Title - Sujet Simulator/Workshop Building	
Solicitation No. - N° de l'invitation F1700-110664/A	Amendment No. - N° modif. 003
Client Reference No. - N° de référence du client F1700-110664	Date 2012-06-13
GETS Reference No. - N° de référence de SEAG PW-\$PWY-020-6701	
File No. - N° de dossier PWY-2-35032 (020)	CCC No./N° CCC - FMS No./N° VME
Solicitation Closes - L'invitation prend fin at - à 02:00 PM on - le 2012-06-26	Time Zone Fuseau horaire Pacific Daylight Saving Time PDT
F.O.B. - F.A.B. Plant-Usine: <input type="checkbox"/> Destination: <input checked="" type="checkbox"/> Other-Autre: <input type="checkbox"/>	
Address Enquiries to: - Adresser toutes questions à: Ly, Ronny(PWY)	Buyer Id - Id de l'acheteur pwy020
Telephone No. - N° de téléphone (604) 666-0043 ()	FAX No. - N° de FAX (604) 775-6633
Destination - of Goods, Services, and Construction: Destination - des biens, services et construction: DFO - Coast Guard Station - Bamfield, B.C.

Vous trouverez l'addenda n° 2 ci-joint.

Project: Simulator/Workshop Building

Addendum No.: 002

LOWER FLOOR AND FOUNDATION 1/A-2.0

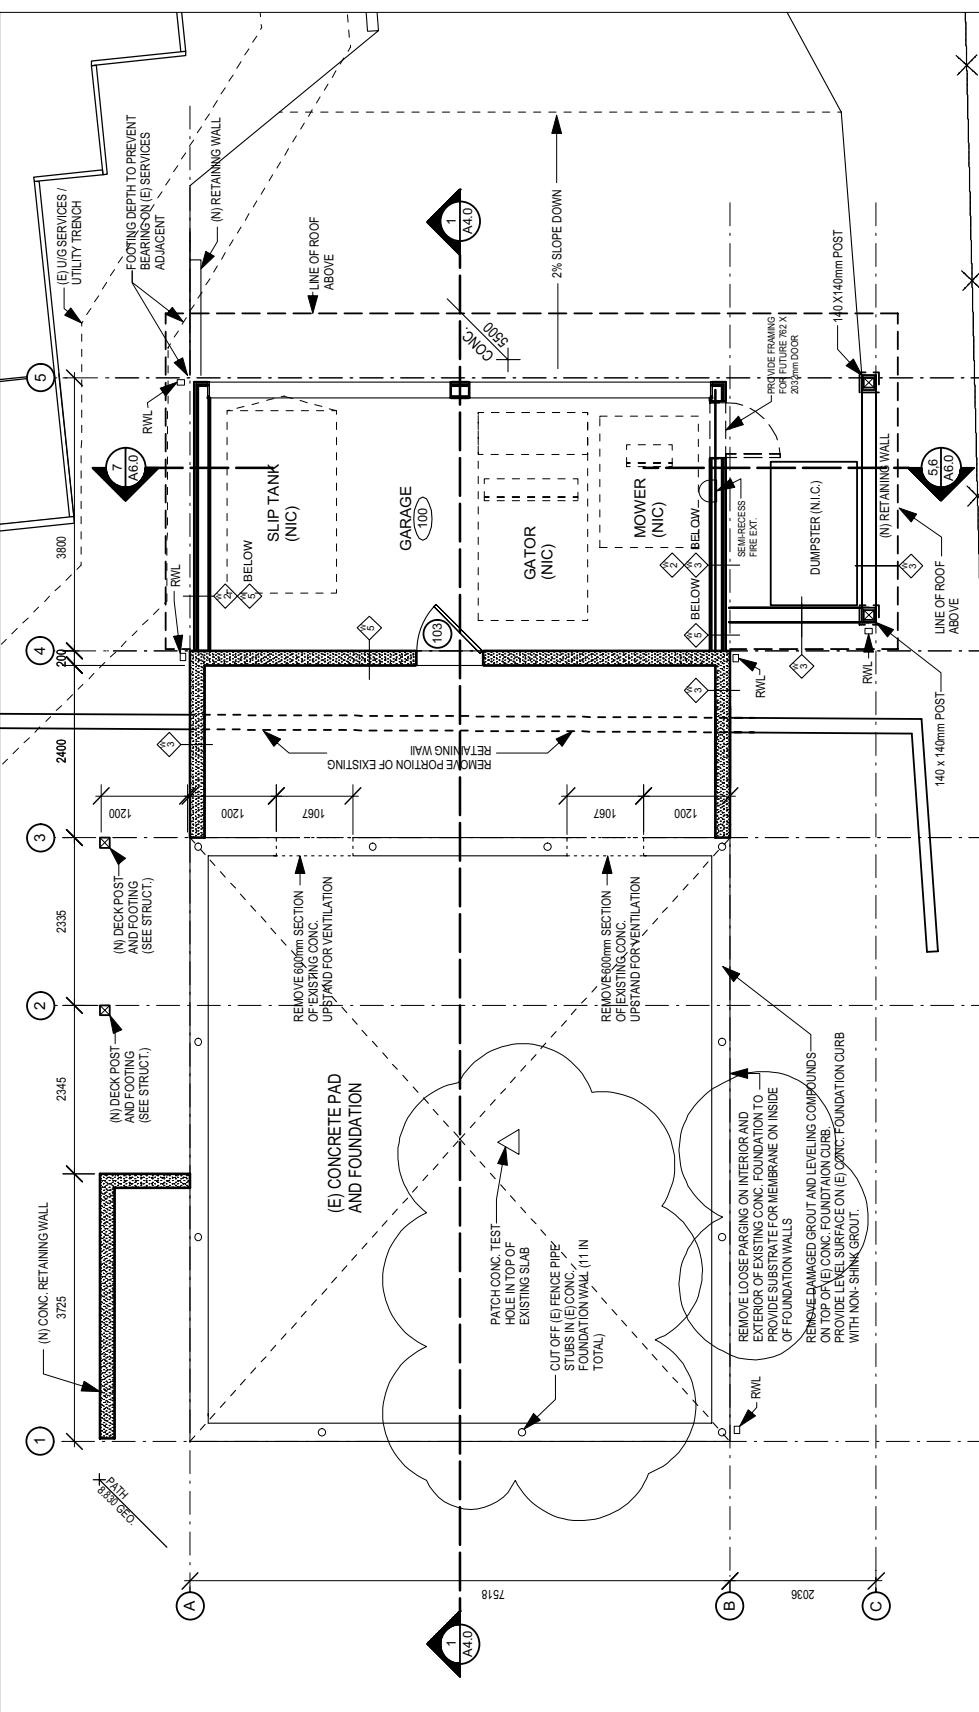
1. Drawing A-2.0 -Assemblies

-Delete all references to Galvalume on drawing A-2.0 (roof assem.) Refer to spec for roof material.

2. Drawing A-2.0 –See ASK-04

- Patch conc. test hole in top of existing slab.
- Cut off existing fence pipe stubs in existing conc. foundation wall (11 in total)
- Remove loose parging on interior and exterior on existing conc. foundation to provide substrate for membrane on inside of conc. foundation walls.
- Power wash & re-parge North and South sides of existing foundation.

M100A

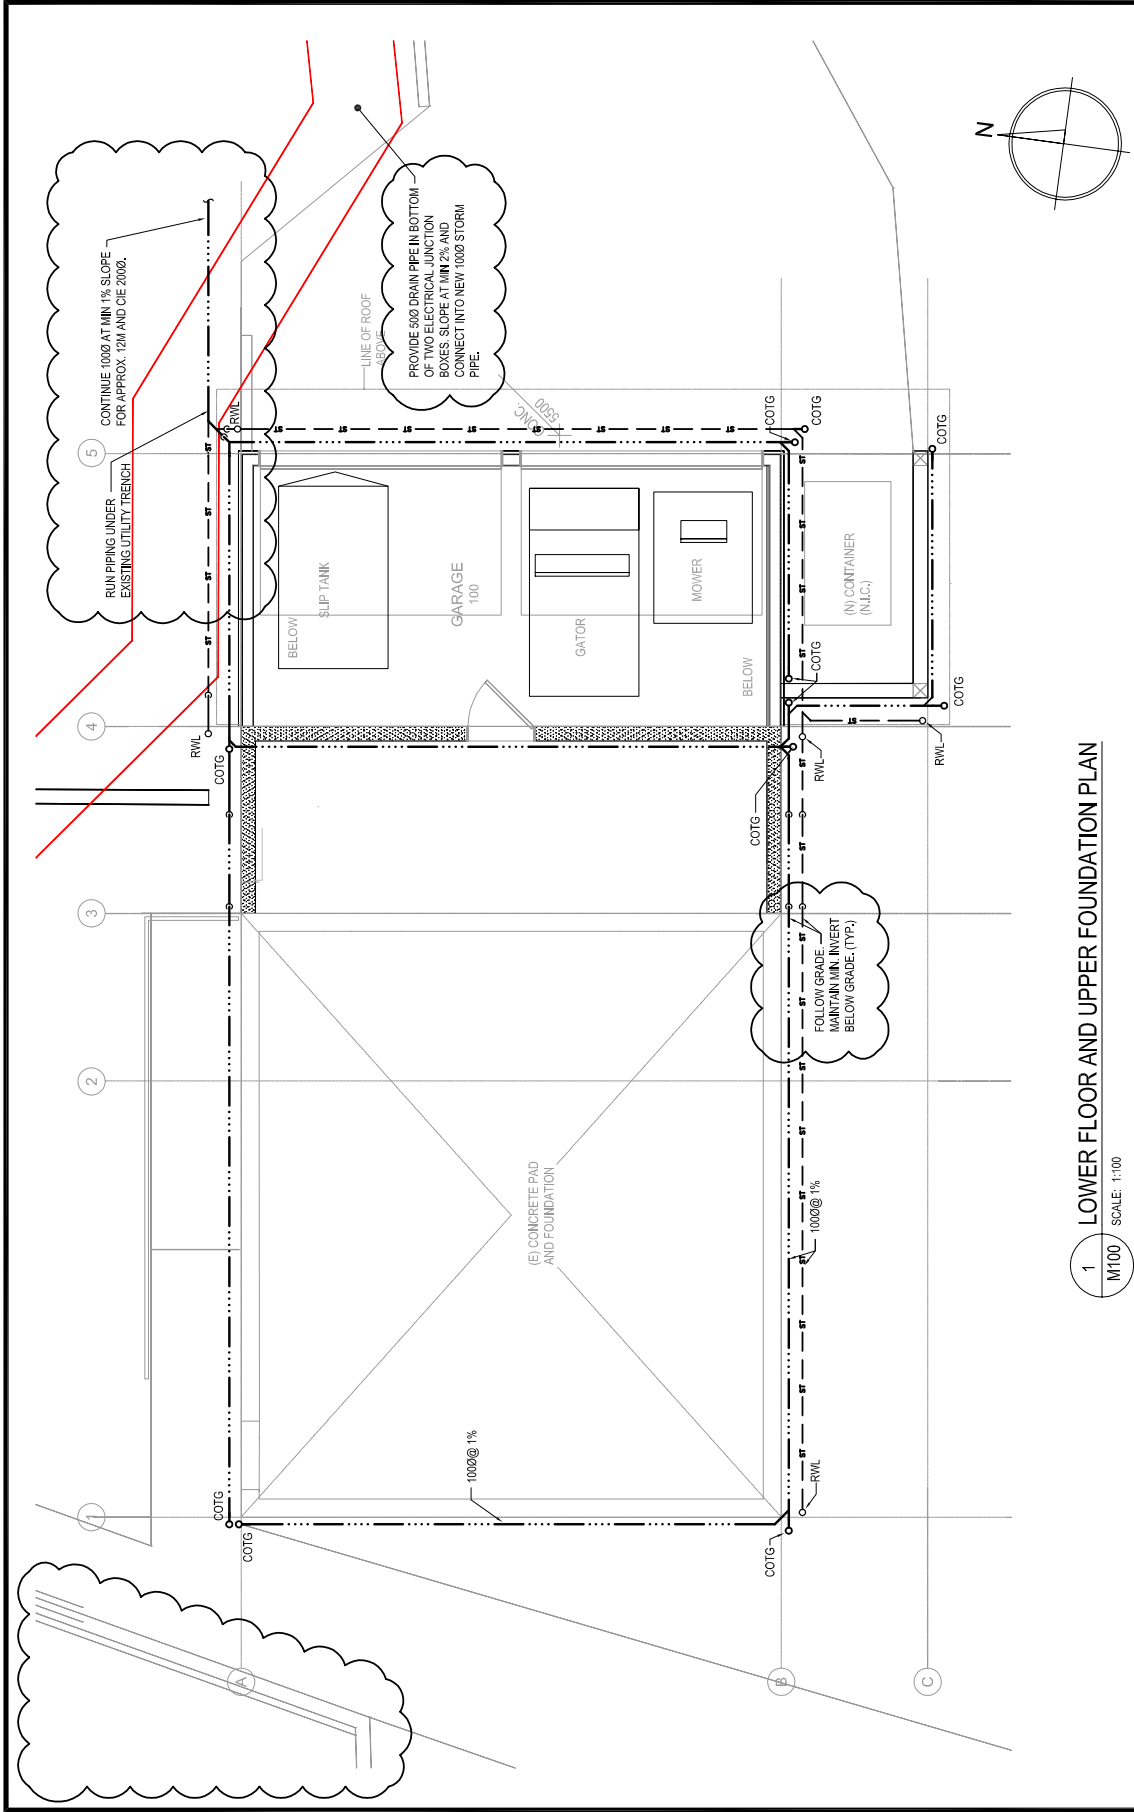
1. Refer to drawing M100A.
 - a. The retaining wall near grid A-1 will not be installed in this project. Delete the perforated pipe serving this retaining wall.
 - b. Combined storm piping leaving the building near grid A-5 shall be directed East approximately 12m and connected into the existing 200mm diameter drain pipe.
 - i. Provide 50mm diameter drain pipes into the bottom of two adjacent Electrical junction boxes and connect into the new 100mm diameter storm pipe.
 - c. Storm piping shall follow the grade along the building, maintaining a minimum depth.
